**APPLICATION FOR CERTIFICATION 07-AFC-7  
SUPPLEMENT A**

**KRCD COMMUNITY  
POWER PLANT**

Re: Supplemental Information in Response to CEC Data Adequacy Request for the Kings River Conservation District Community Power Plant Application for Certification (07-AFC-07)

**KINGS RIVER CONSERVATION DISTRICT COMMUNITY POWER PLANT  
APPLICATION FOR CERTIFICATION (07-AFC-7)  
SUPPLEMENT A**

**KRCDD COMMUNITY POWER PLANT**  
*Energy for our Future*

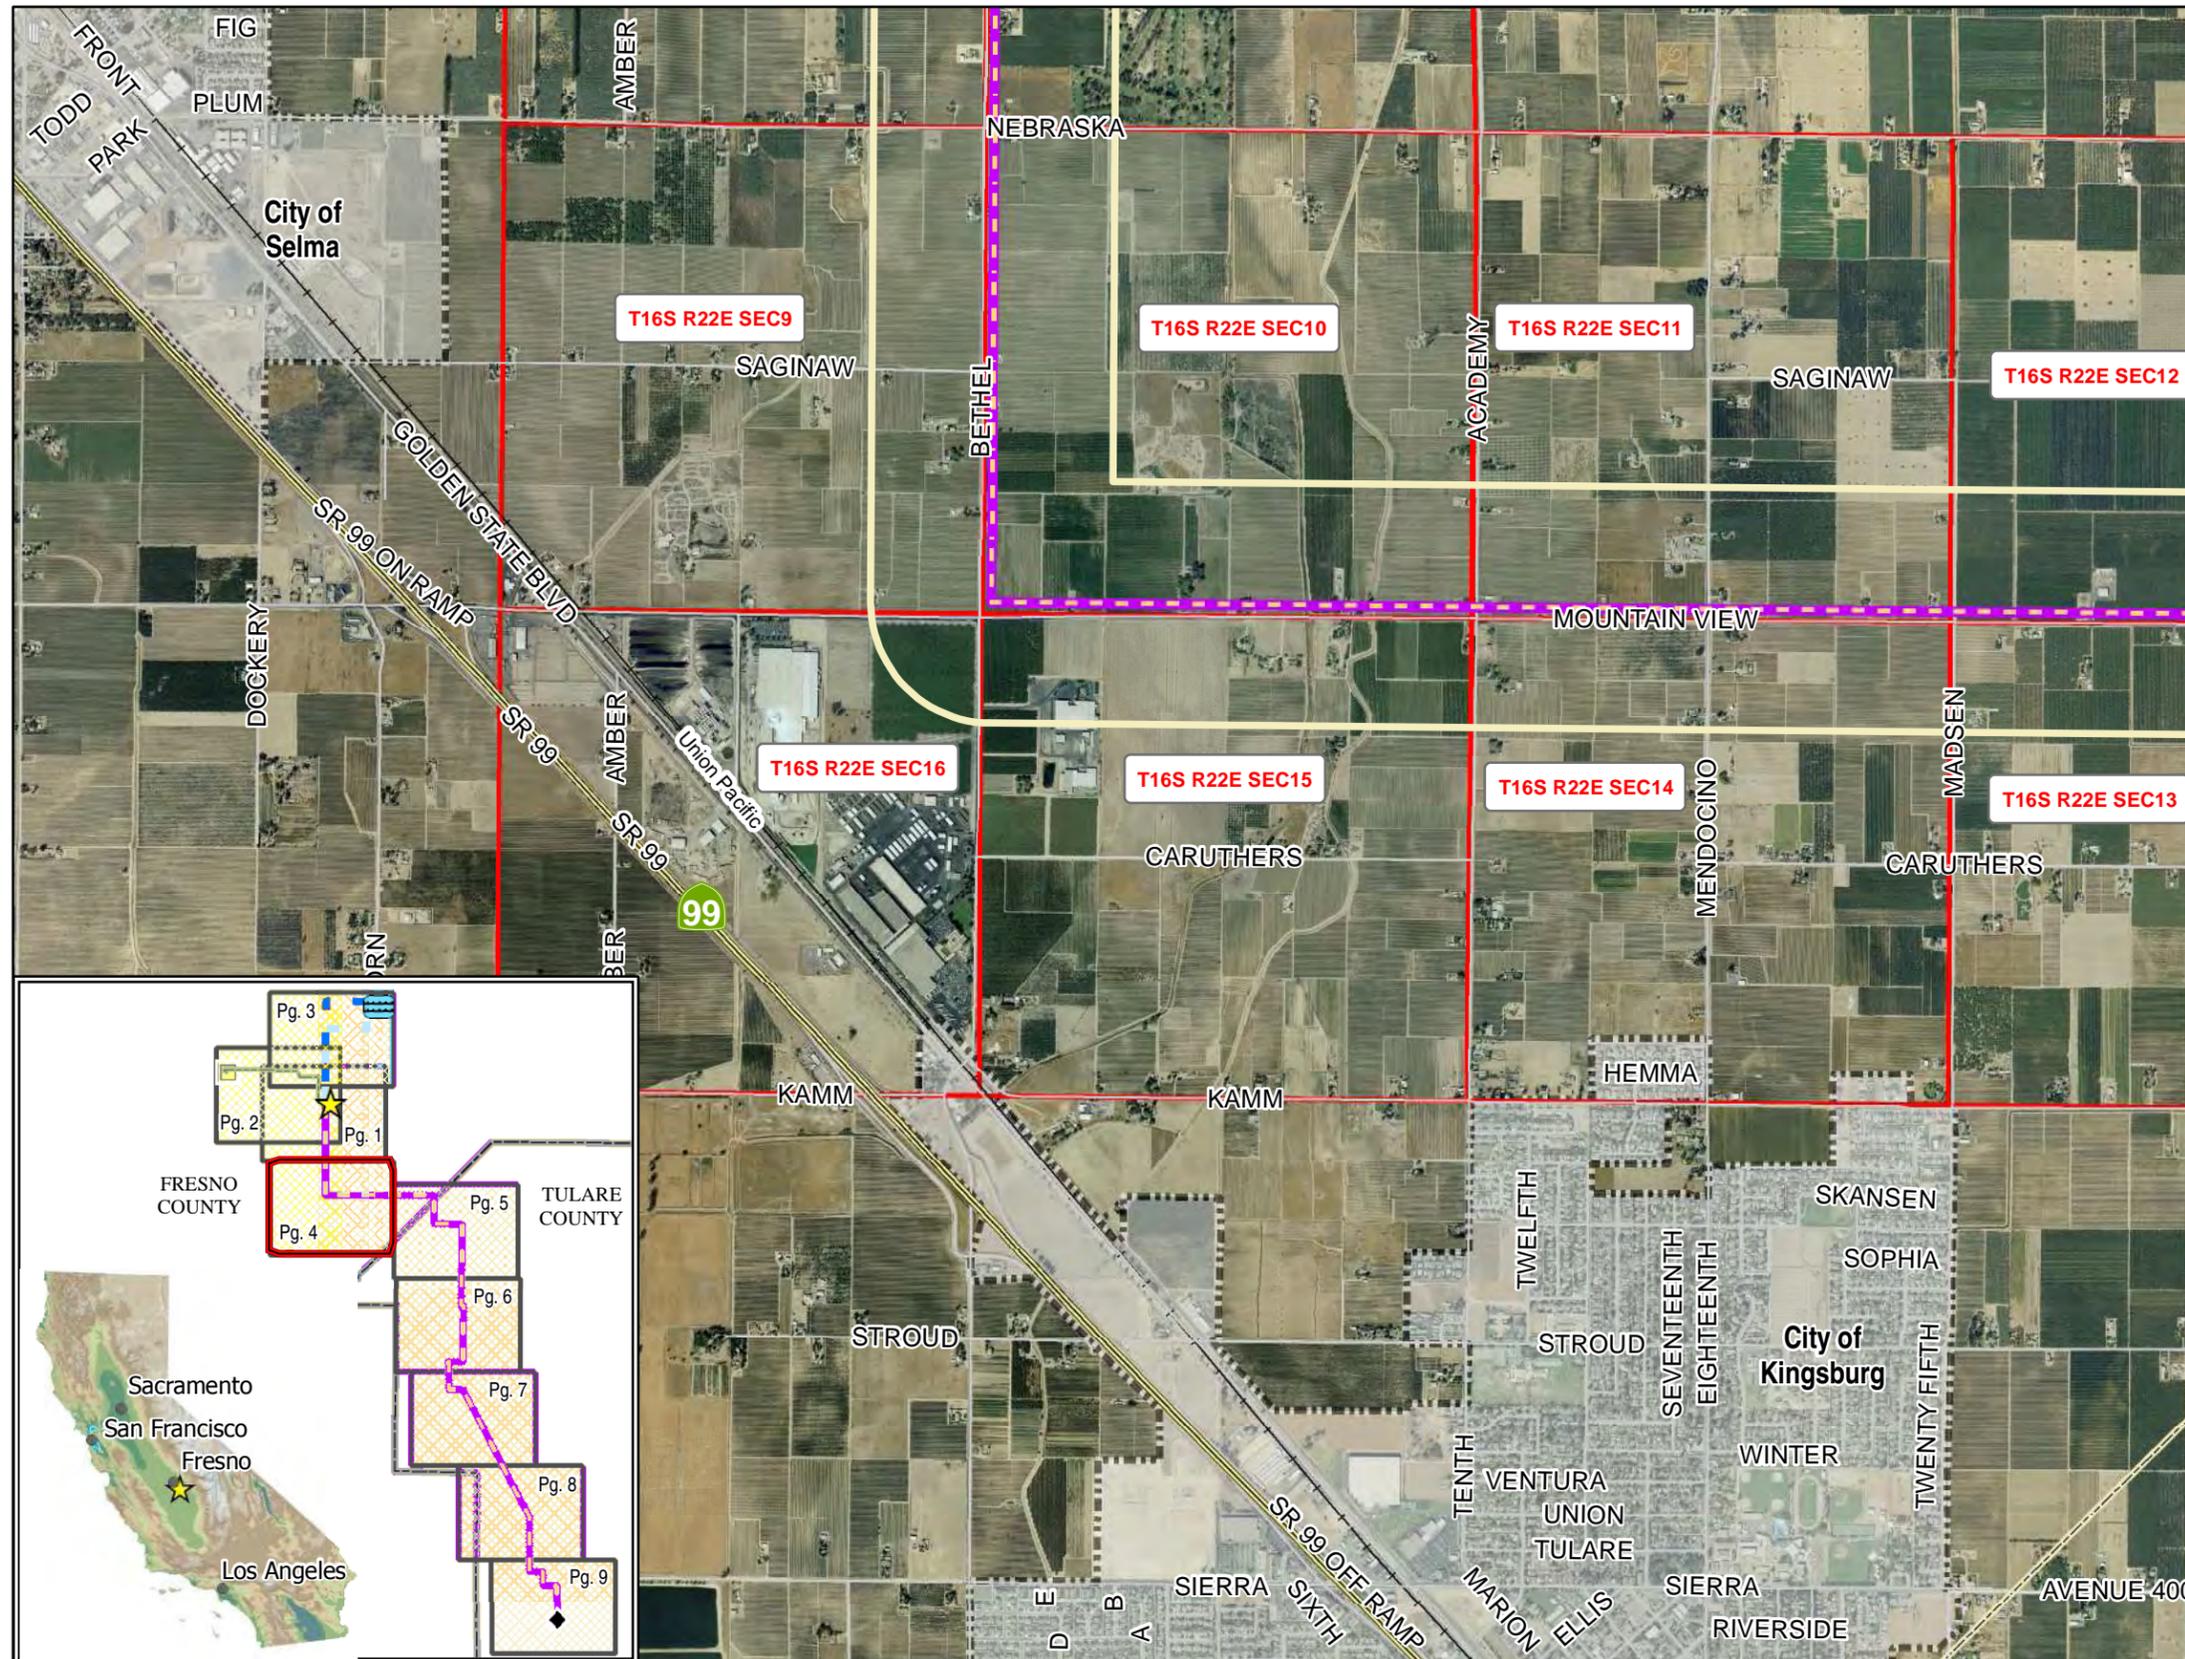
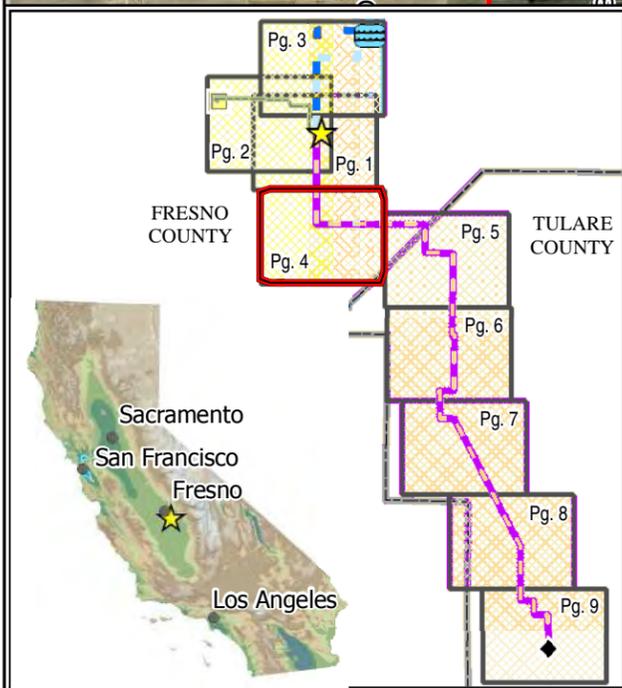
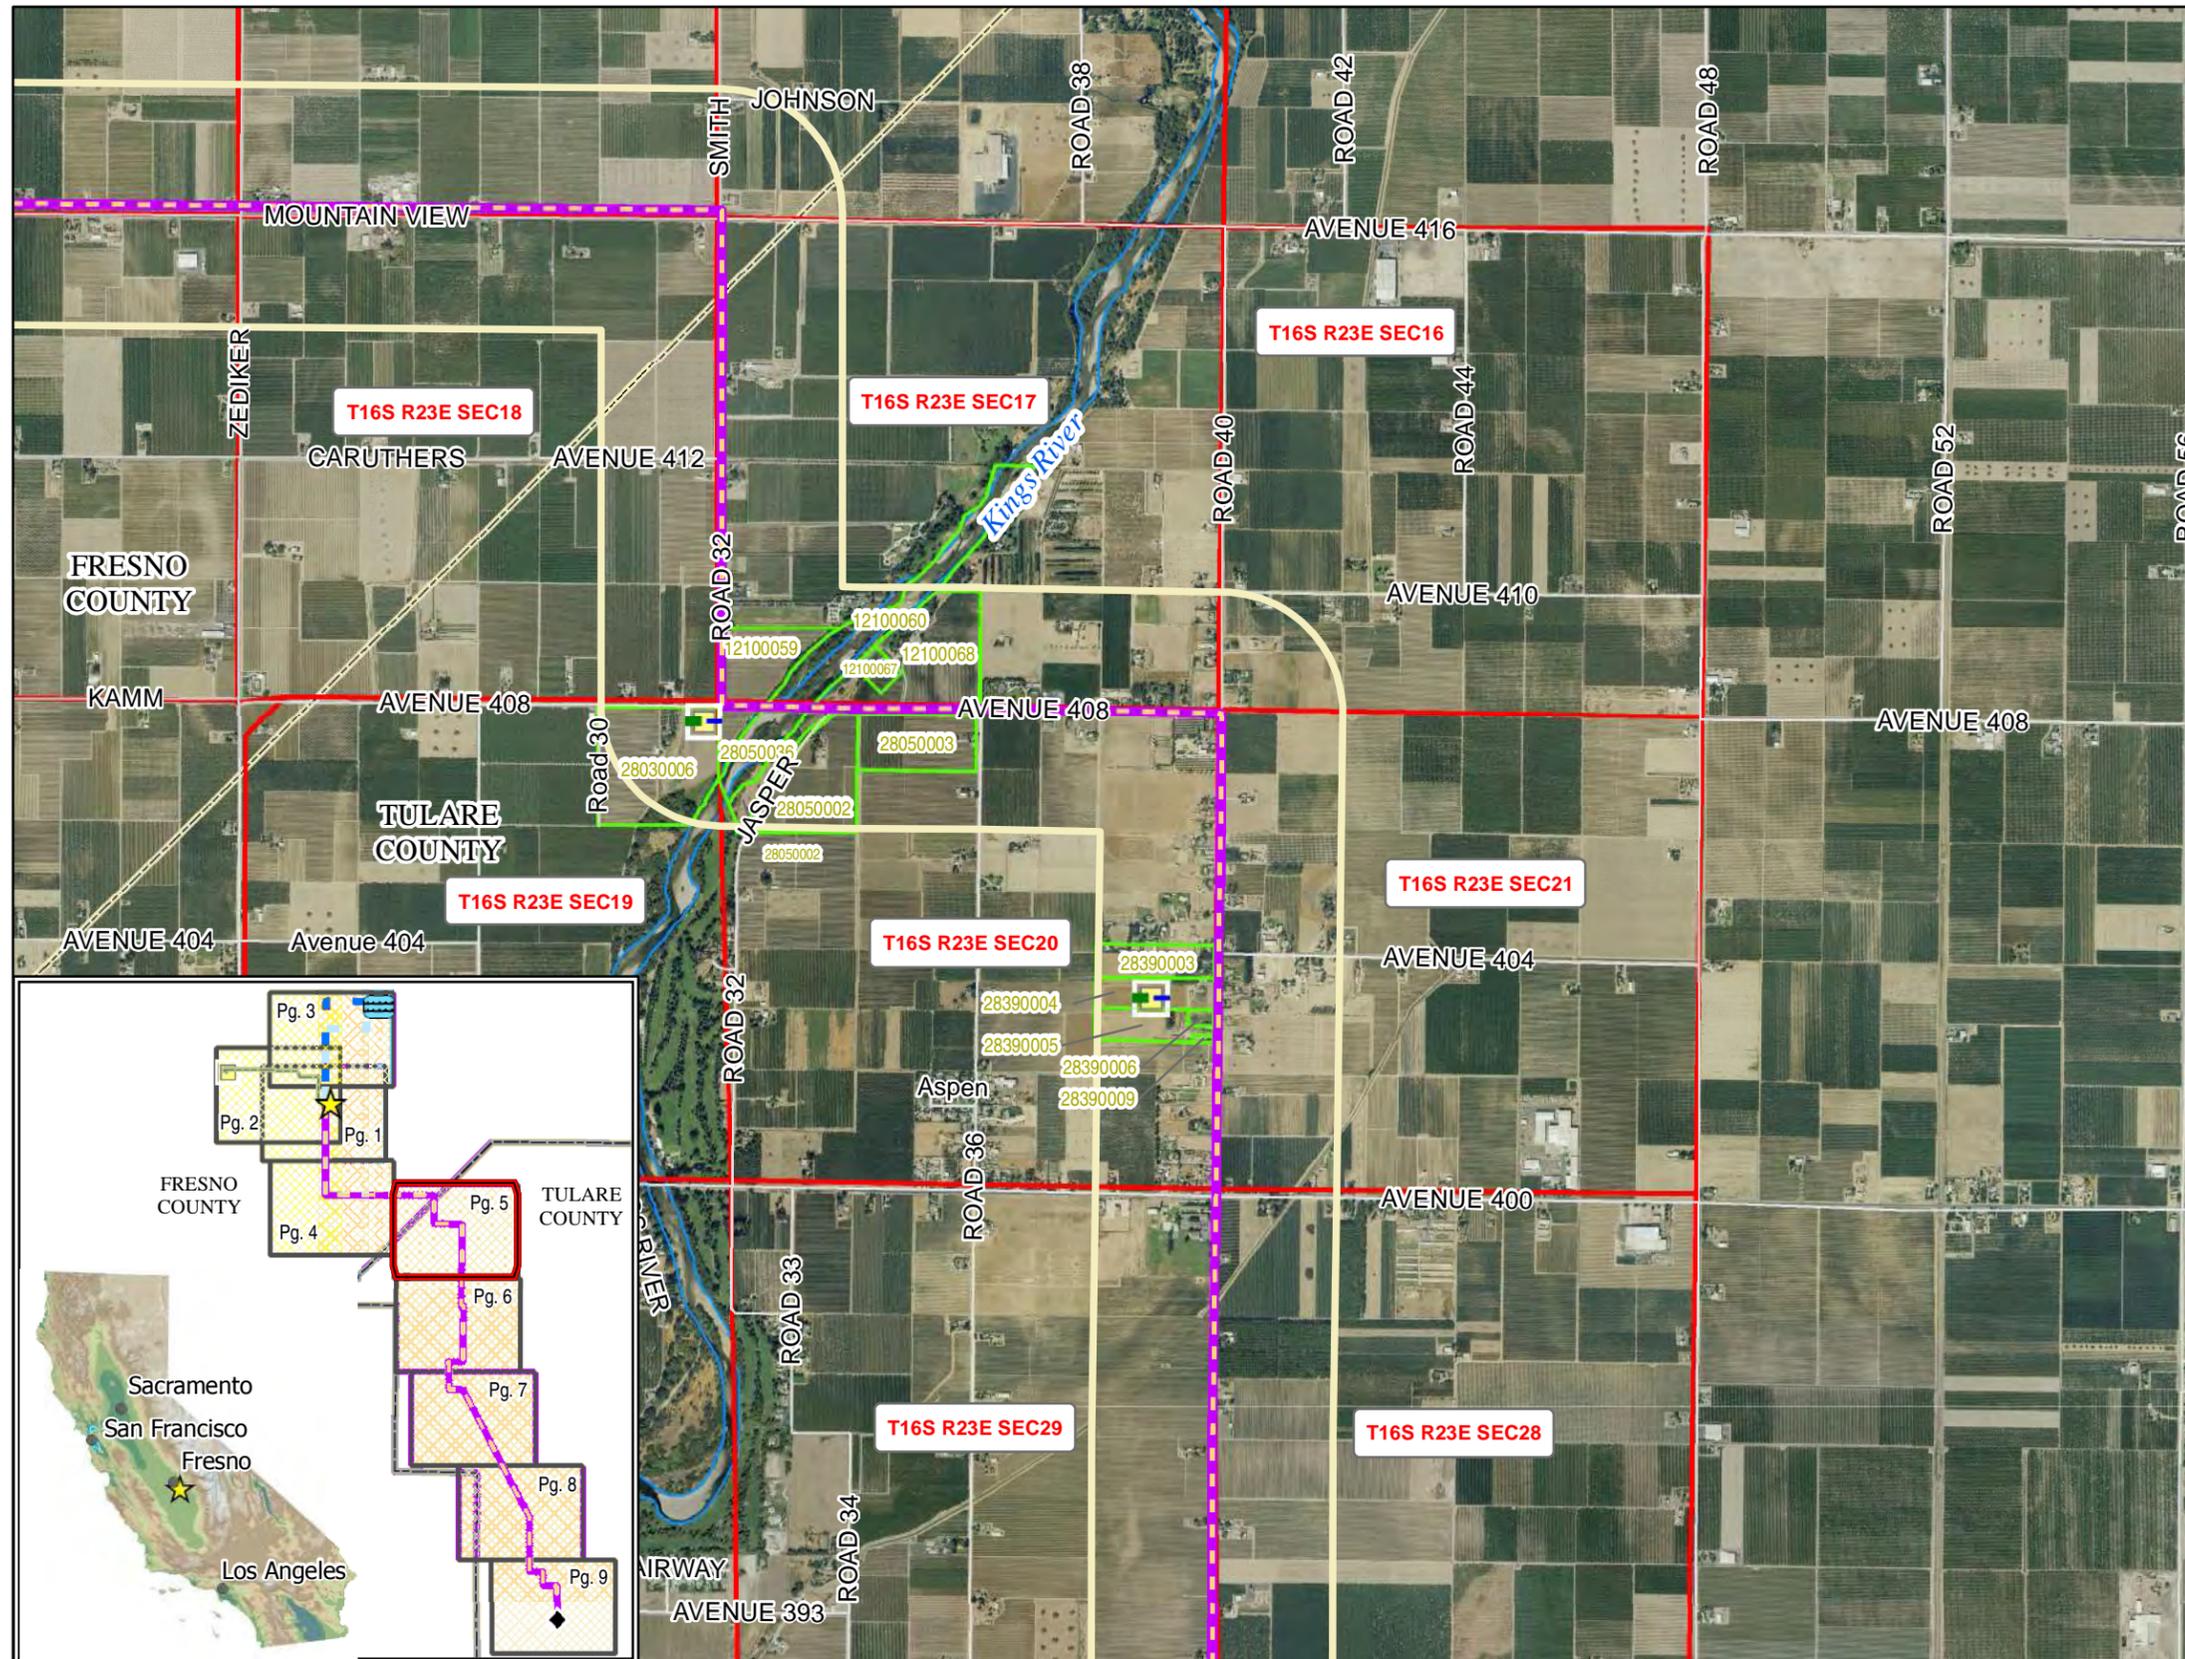
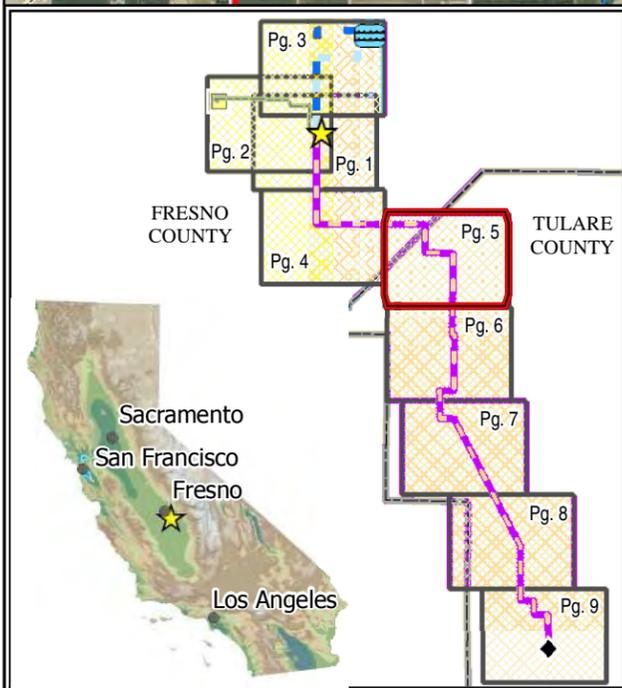
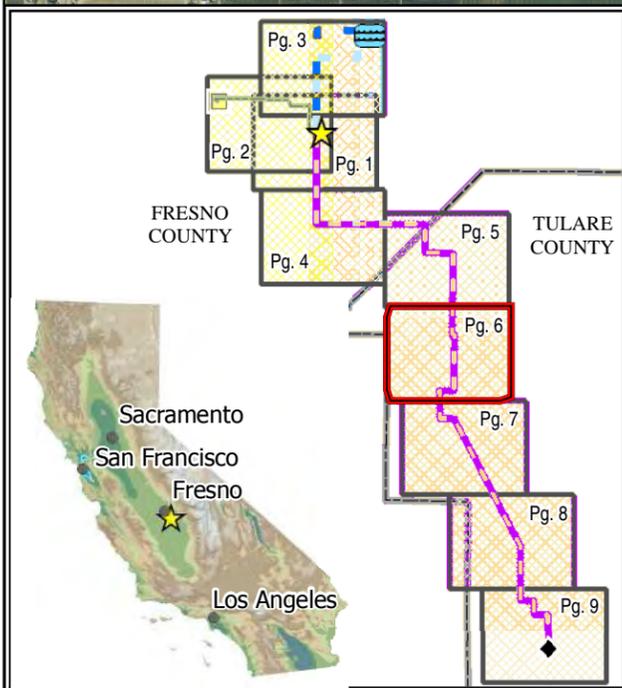
Provide the section, township, range, county, and county assessor's parcel number for the proposed water, gas, or transmission interconnection routes.

Included as Attachment PO-2, are revised Figure 1-3 - KRCD CPP Project Area and revised Figure 2-7 - KRCD CPP Site and Land Description. The revised figures include applicable section, township, and range information as well as the county assessor's parcel numbers for areas where the KRCD CPP project area crosses private property. The attached revised Figures 1-3 and 2-7 should replace Figures 1-3 and 2-7 in KRCD CPP AFC Volume 3.
